ADDENDUM NO. 3

RIVERWALK WEST FINAL PHASE

BID #26-012

ISSUED: May 22, 2026

EL011

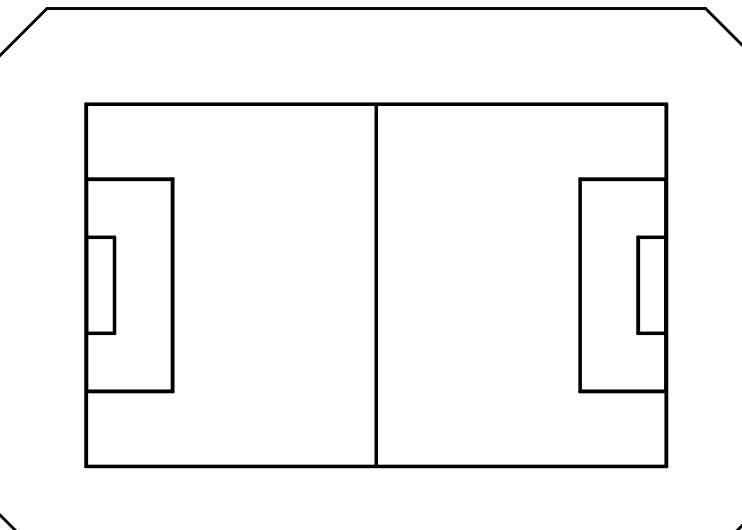
Q15: Can you provide further detail on the electrical. Are you able to provide a spec, supplier or details on the light pole and fixture. Is there room in the panel for these additional loads? Is there a timer required? More details on the electrical scope would be helpful since it is design build.

A15: *Response- See attachment B for light type S2 specs from the adjacent stadium project. Installation of conduit, wire, foundations, and light fixtures shall be included in the Base Bid. The Bid Form has been modified to include the design of new service as a Bid Alternate. This will include all accessories required to complete the work such as timer, new cabinet, panel and foundation, and coordination with Rhode Island Electric to design and install the service.*
